In re Patent No. 6,032,898

Title: MULTIPLE ROLL TOWEL DISPENSER

**PETITION FOR CERTIFICATE OF CORRECTION  
PURSUANT TO 37 C.F.R. §§ 1.322 and 1.323**

FIG. 2

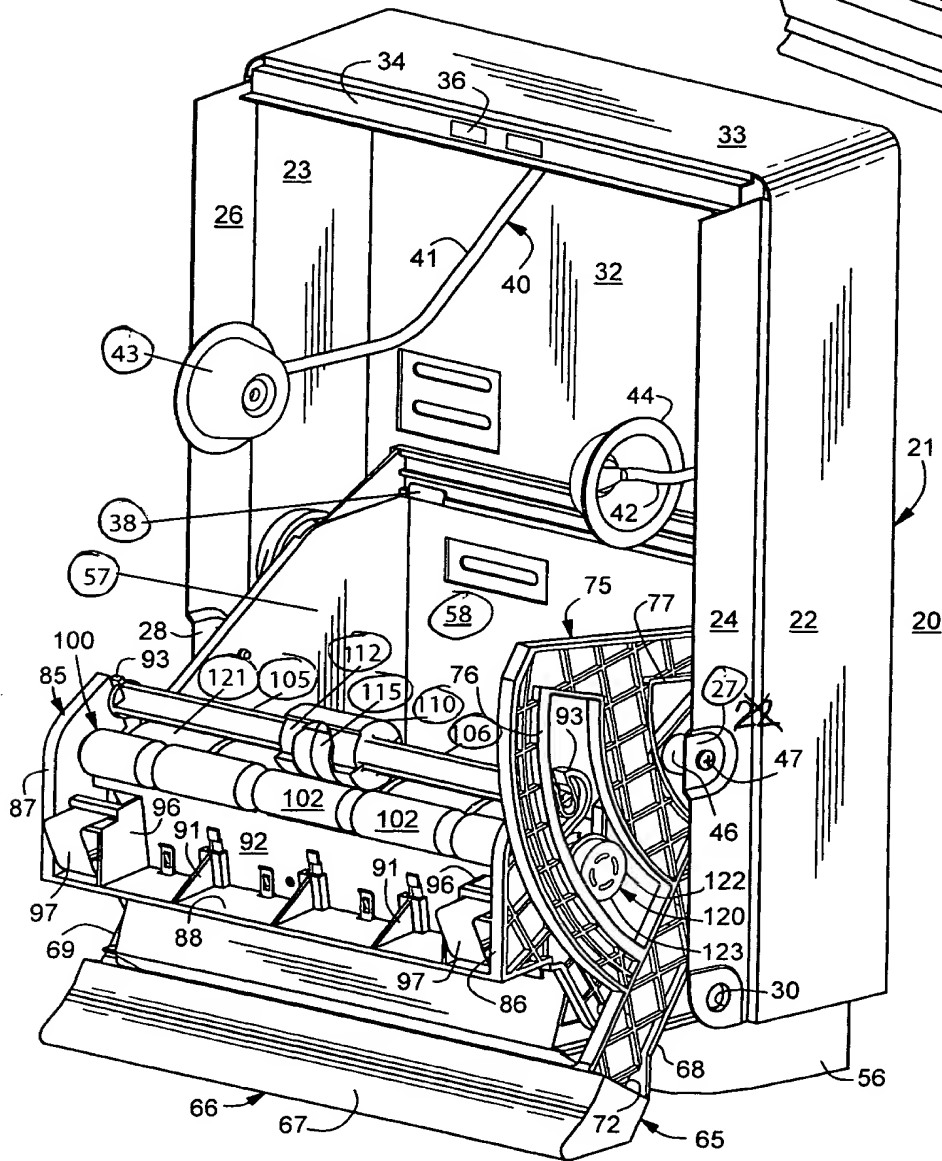
In the drawings, sheet 1, Fig. 2, reference numeral "22" on the sidewall of outwardly extending flange 24 should be deleted and reference numeral --27-- should be applied to the stamped portion;

In the drawings, sheet 1, Fig. 2, reference numeral --43-- should be applied to the left-hand side hub of the paper roll holder assembly 40; reference numeral --58-- should be applied to

the rear wall of the chassis 55; reference numeral --57-- should be applied to the left-hand side spaced parallel side wall of chassis 55; reference numeral --38-- should be applied to the clip extending from the rear wall 32 of the housing 21.

In the drawings, sheet 1, Fig. 2, reference numeral --121-- should be applied to the drive roller segments of the drive roller 120.

In the drawings, sheet 1, Fig. 2, reference numeral --105-- should be applied to the transfer roller assembly; reference numeral --106-- should be applied to the shaft 106 of the transfer roller assembly 105; reference numeral --110-- should be applied to the transfer mechanism; reference numeral --112-- should be applied to the indented or removed portion of the cylindrical portion 111 of the shaft 106; reference numeral --115-- should be applied to the snap clip which receives the indented or removed portion 112 of the cylindrical portion 111 of the shaft 106.

FIG. 6

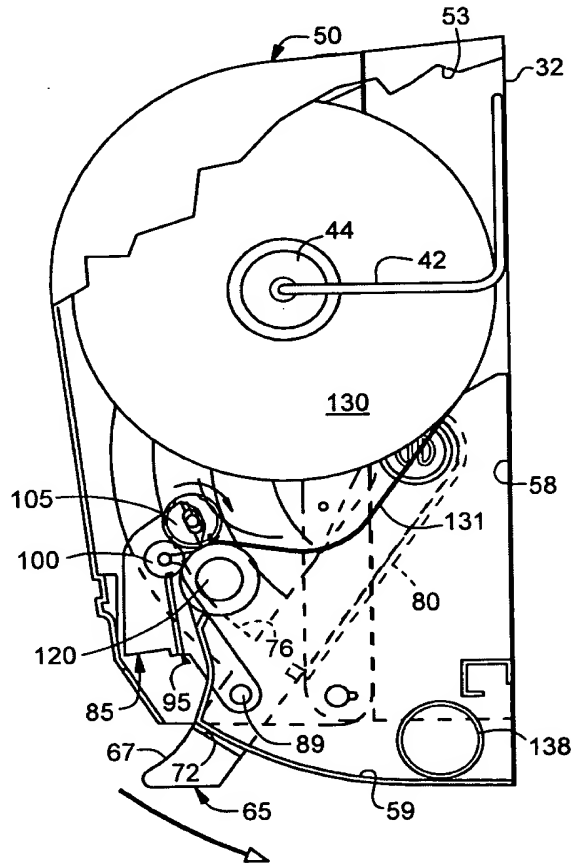
In the drawings, sheet 3, Fig. 6, the reference numeral "50" (not the reference numeral "50" pointing to the cover) should be deleted and reference numeral --51-- should be applied to the front panel of the cover 50.

**FIG. 14**

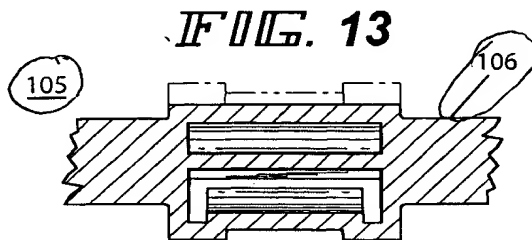
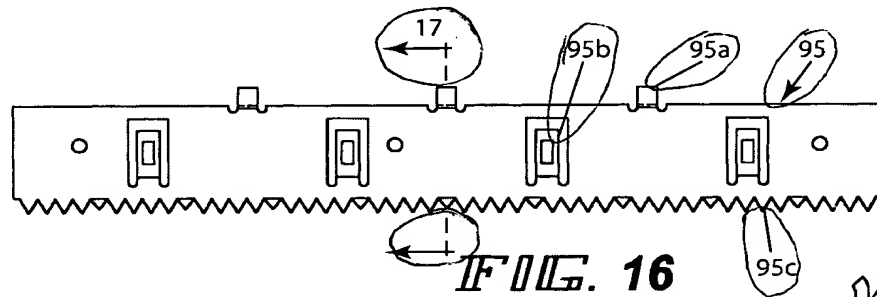
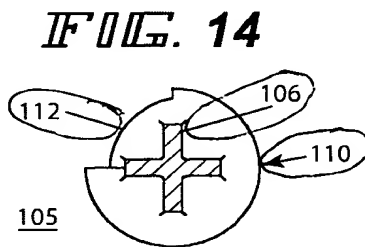
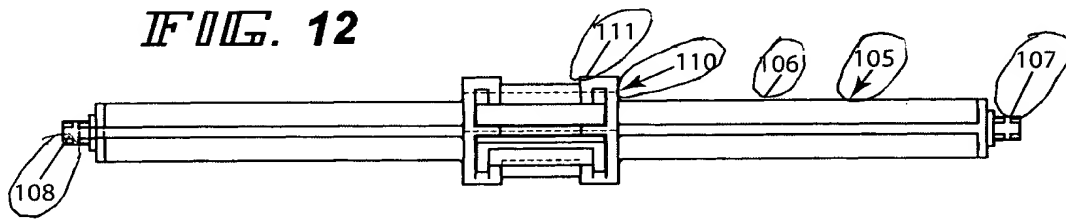
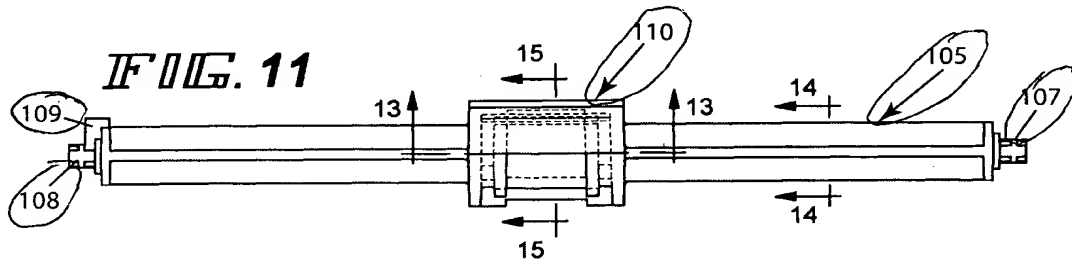
In the drawings, sheet 5, Fig. 11, reference numeral --105-- should be applied to the transfer roller assembly; reference numeral --107-- should be applied to the journal on the right-hand end of the transfer roller assembly 105; reference numeral --108-- should be applied to the

journal on the left-hand end of the transfer roller assembly 105; reference numeral --109-- should be applied to the stop plate on journal 108; and reference numeral --110-- should be applied to the transfer mechanism positioned generally centrally of the shaft of the transfer roller assembly 105.

In the drawings, sheet 5, Fig. 12, reference numeral --105-- should be applied to the transfer roller assembly; reference numeral --106-- should be applied to the shaft of the transfer roller assembly 105; reference numeral --107-- should be applied to the journal on the right-hand end of the transfer roller assembly 105; reference numeral --108-- should be applied to the journal on the left-hand end of the transfer roller assembly 105; reference numeral --110-- should be applied to the transfer mechanism positioned generally centrally of the shaft 106; and reference numeral --111-- should be applied to cylindrical portion of the shaft 106.

In the drawings, sheet 5, Fig. 13, reference numeral --105-- should be applied to the transfer roller assembly; and reference numeral --106-- should be applied to the shaft of the transfer roller assembly.

In the drawings, sheet 5, Fig. 14, reference numeral --105-- should be applied to the transfer roller assembly; reference numeral --106-- should be applied to the shaft of the transfer roller assembly 105; reference numeral --110-- should be applied to the transfer mechanism positioned generally centrally of the shaft 106; and reference numeral --112-- should be applied to the indented or removed portion of the cylindrical portion 111 of the shaft 106.

In the drawings, sheet 5, Fig. 15, reference numeral --105-- should be applied to the transfer roller assembly; and reference numeral --116-- should be applied to the groove or

receptacle of the cylindrical portion 111 of the shaft 106.

In the drawings, sheet 5, Fig. 16, reference numeral --95-- should be applied to the tear bar; reference numeral --95a-- should be applied to the tabs of the tear bar 95; reference numeral --95b-- should be applied to the clips of the tear bar 95; reference numeral --95c-- should be applied to the serrated edge of the tear bar 95; and section line 17—17 should be added at the middle portion of the drawing at the top and bottom thereof.

**FIG. 10**

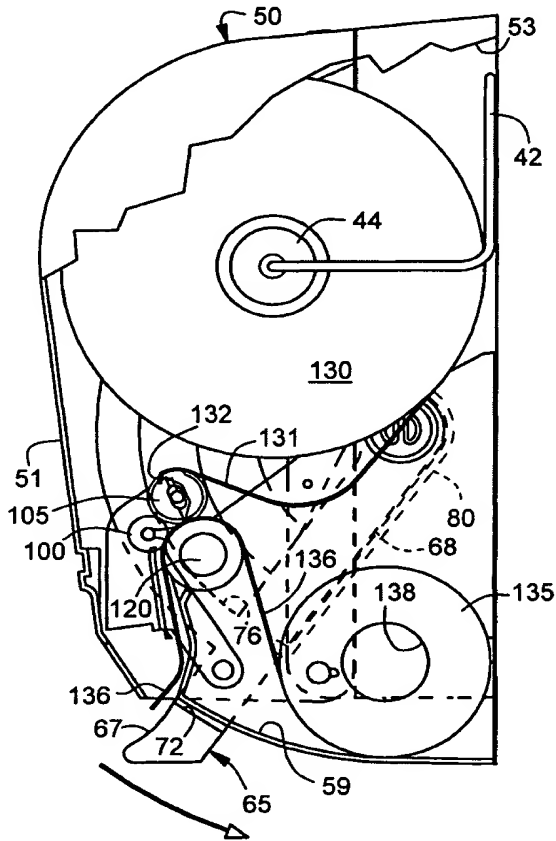
In the drawings, sheet 4, Fig. 10, the reference numeral "131" pointing to the free end of the flight of paper 131 should be deleted and the reference numeral --132-- should be applied to the free end of the flight of paper 131.
